Product Change Notice (PCN)

PCN Number: **PCN-0451150R-01**

Product(s) Affected: PJ-037AH

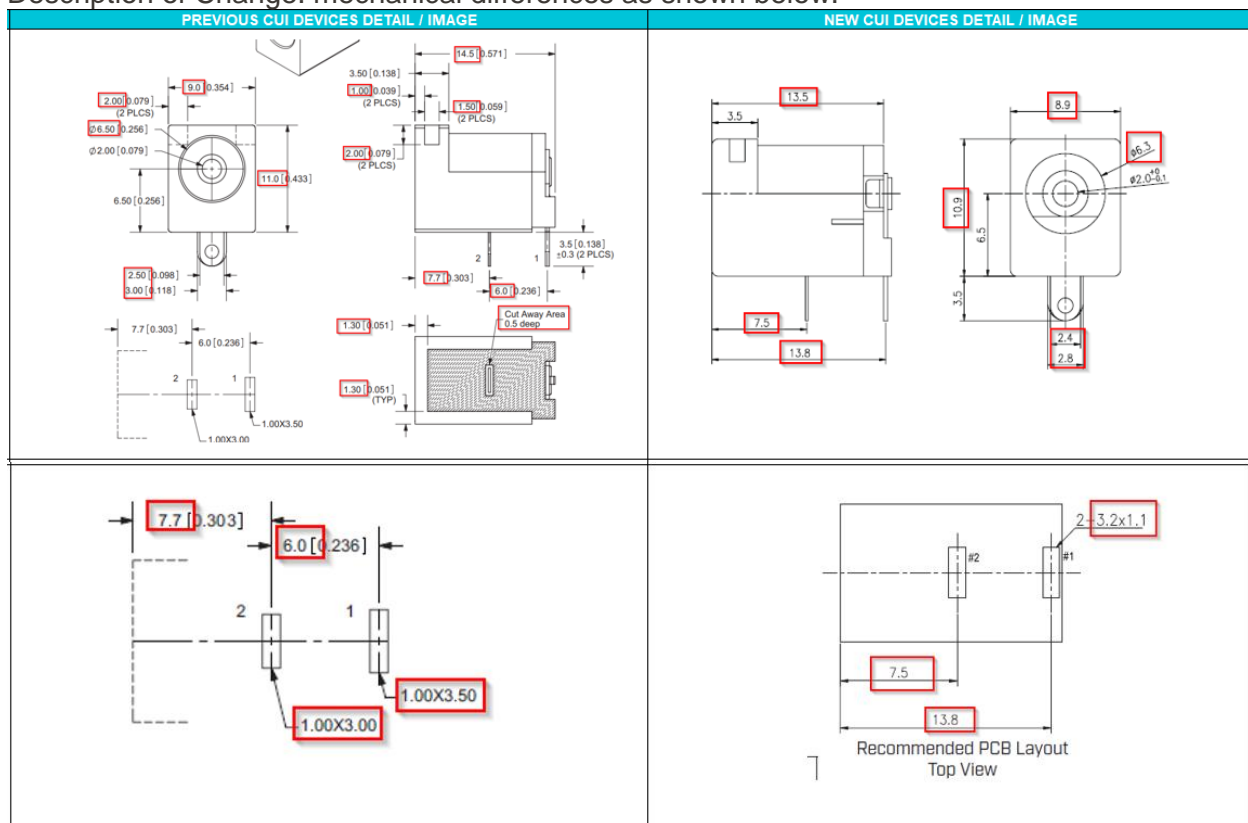
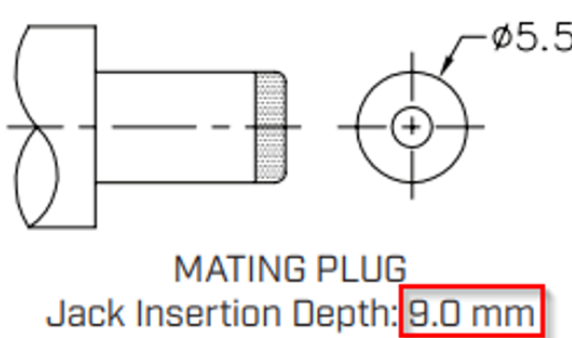
Description of Change: mechanical differences as shown below:

MATERIAL	PLATING
center pin	copper	nickel
terminal 1	brass	silver
terminal 2	copper alloy	silver
plastic	PBT

DESCRIPTION	MATERIAL	PLATING/COLOR
center pin	copper alloy	nickel
terminal 1	brass t=0.3 mm	nickel-silver
terminal 2	phosphor bronze t=0.3 mm	nickel-silver
housing	PBT (UL94V-0)	black
cover	PBT (UL94V-0)	black

MATING PLUG
Jack Insertion Depth: **9.0 mm**

MATING PLUG
Jack Insertion Depth: **9.8 mm**

Insertion/extraction force adjusted to 0.3 ~ 2.0 kg
